PLANNING COMMISSION MEETING

RE: Cosmo's Car Wash- Preliminary Site Plan Review – 2nd Review

RE: Cosmo's Car Wash
Preliminary Site Plan – Review #2

RE: Black Rock
Preliminary Site Plan and Special Land Use – Review #2

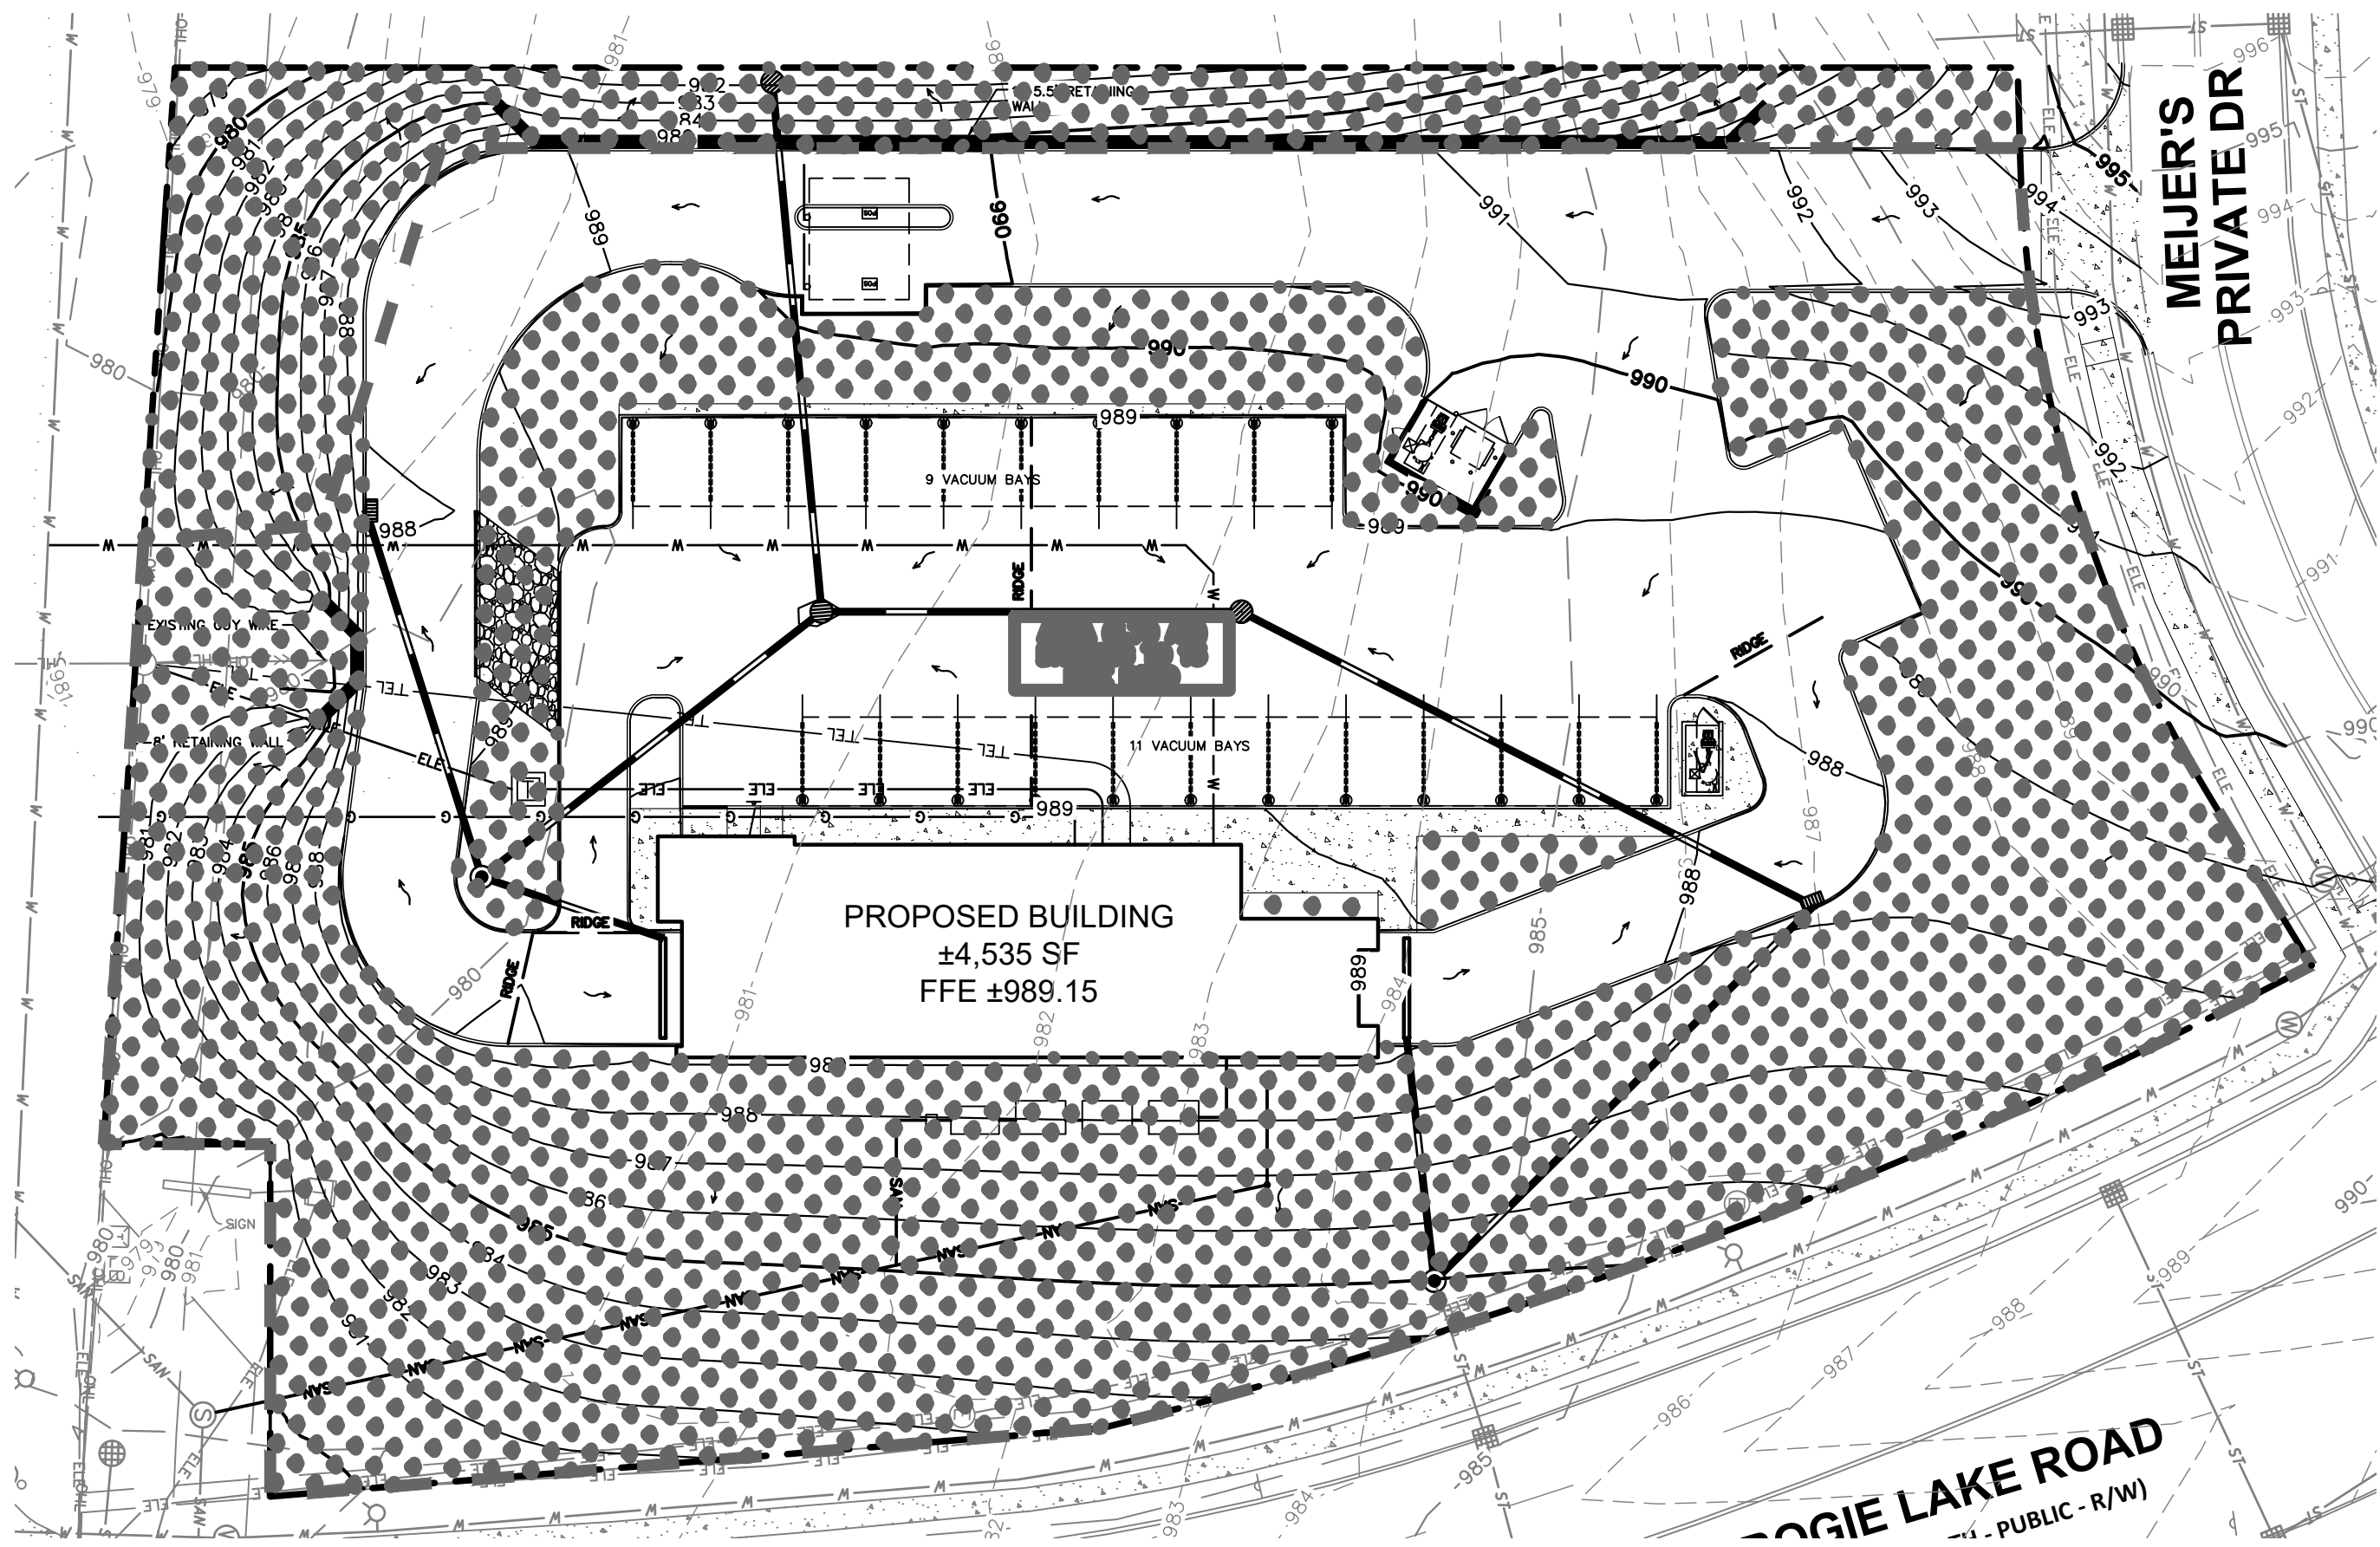
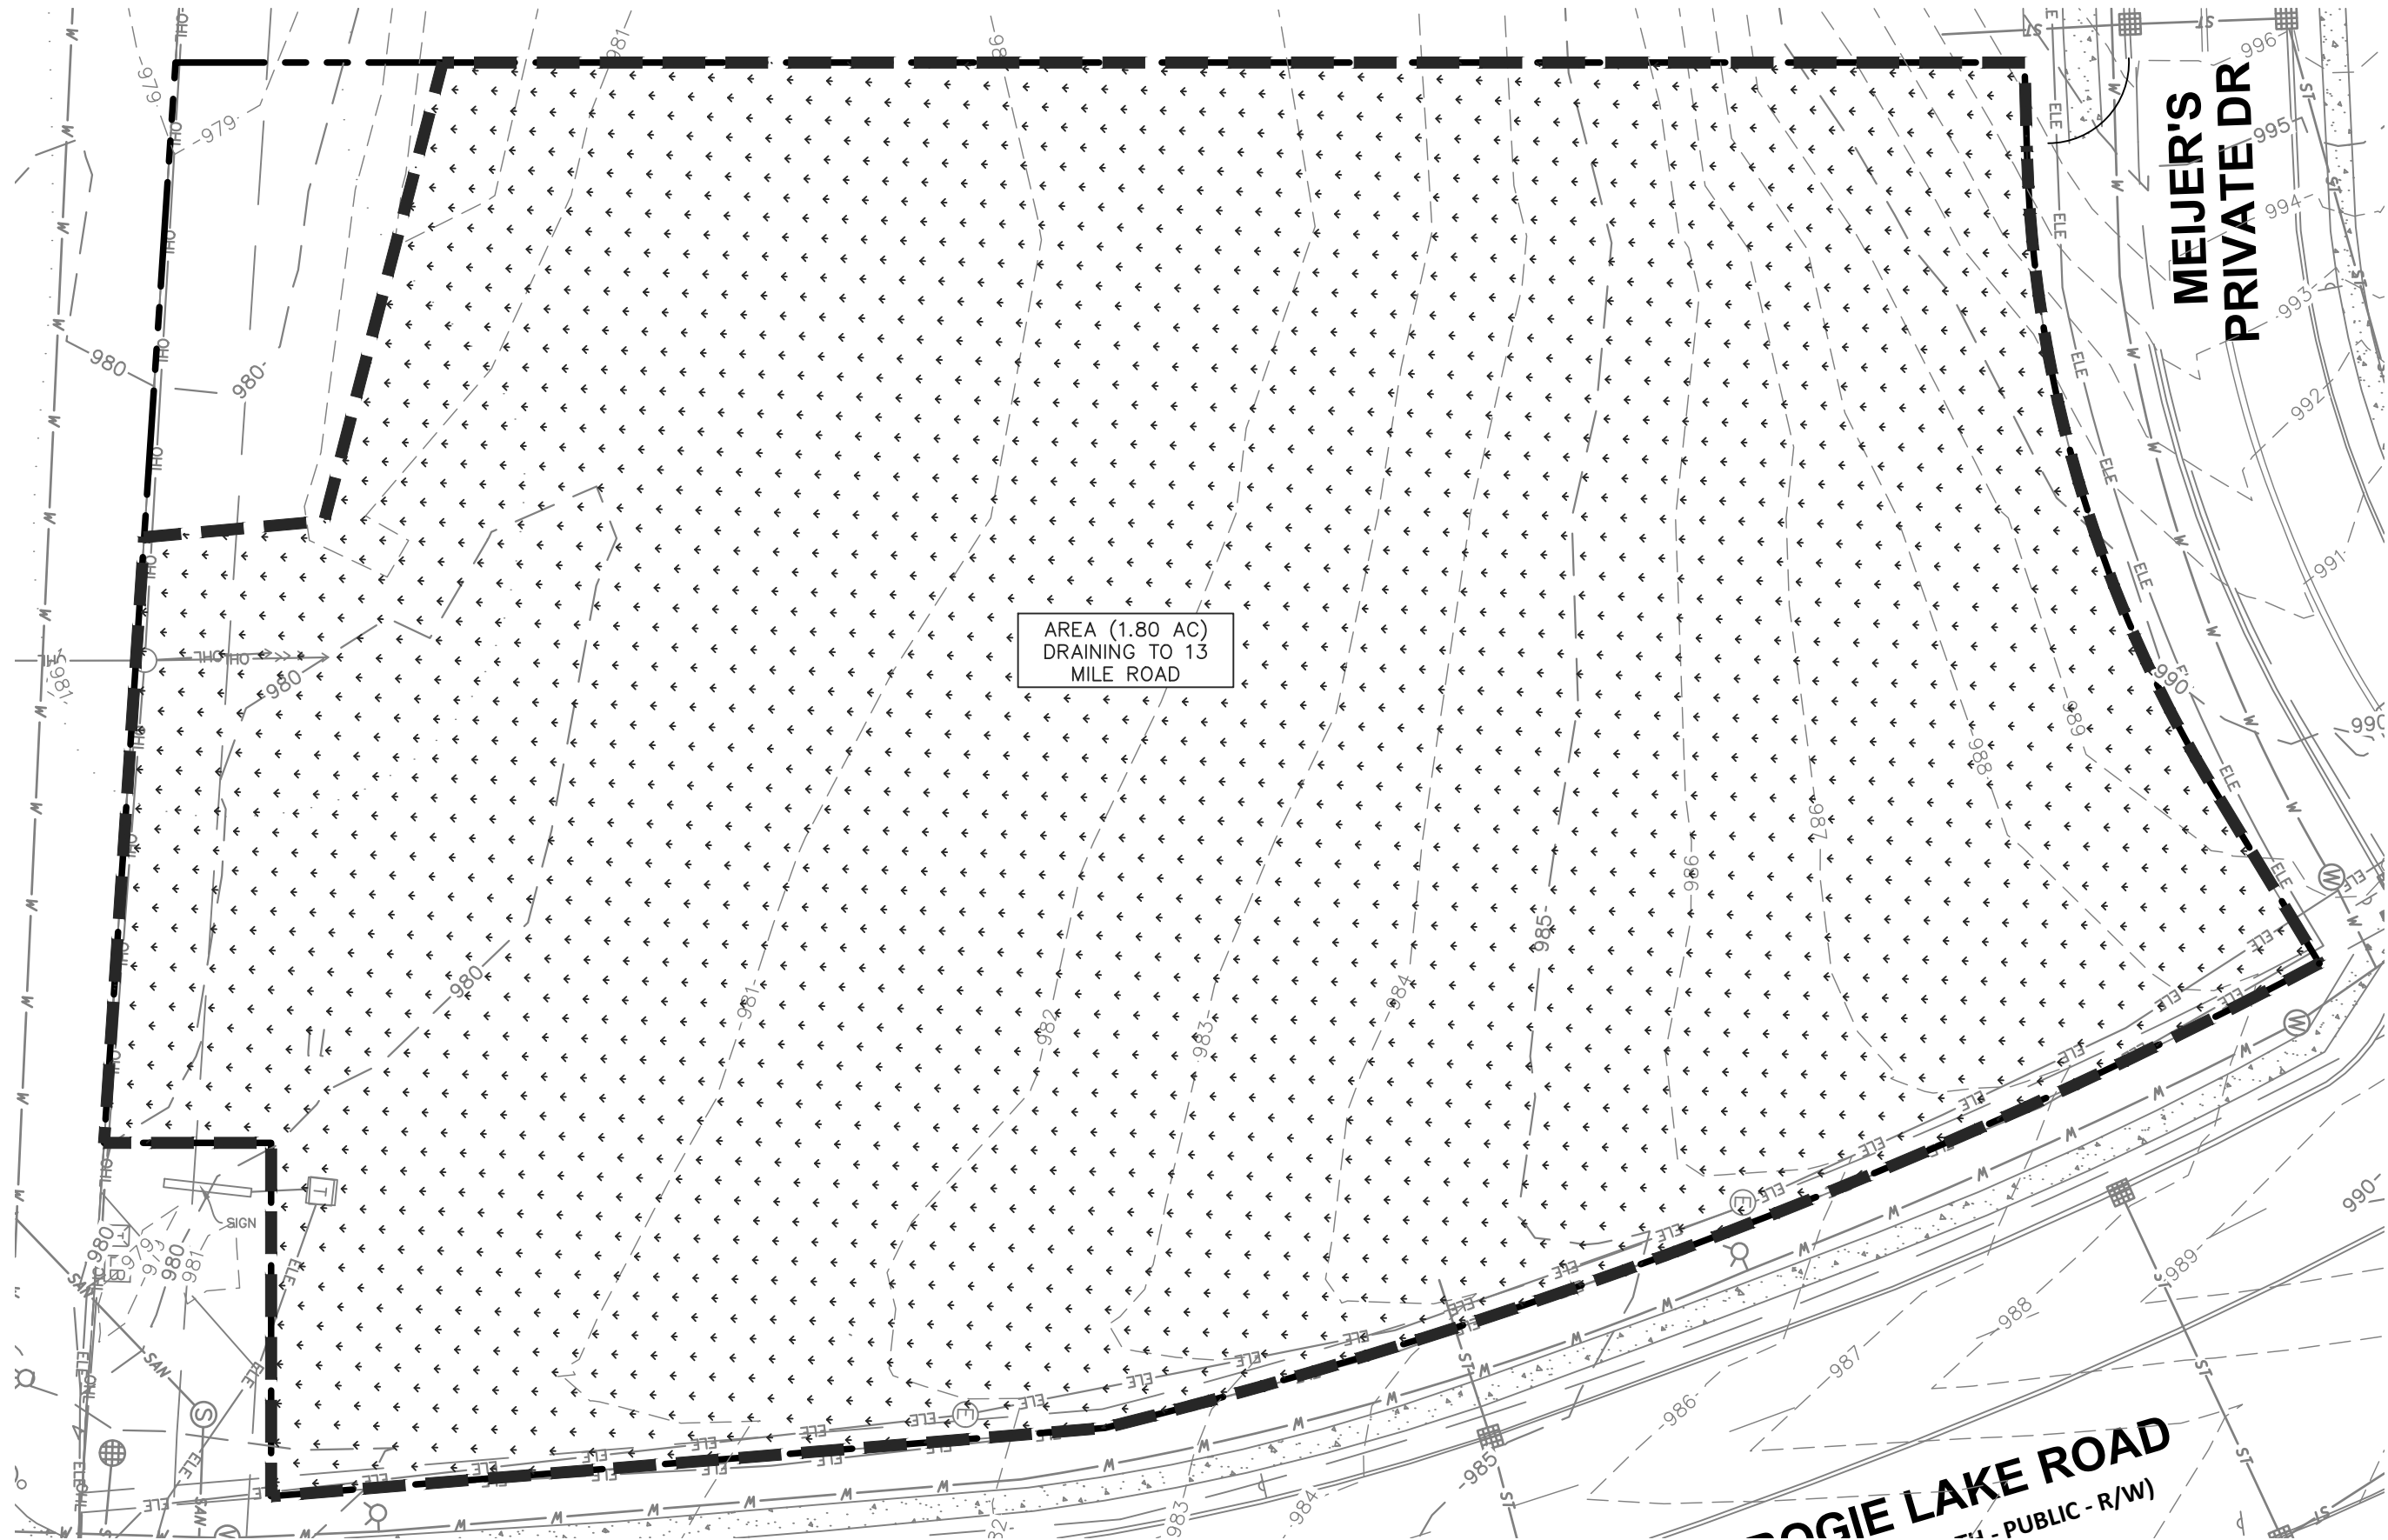
- k) *Show pre versus post development storm drainage that is being routed to the existing storm sewer structure near the corner of Highland Road and Bogie Lake Road. **Comment outstanding. Provide estimated pre- and post -development Q values. In addition, remove all references on this sheet (C4.0) to 13 Mile Road.***
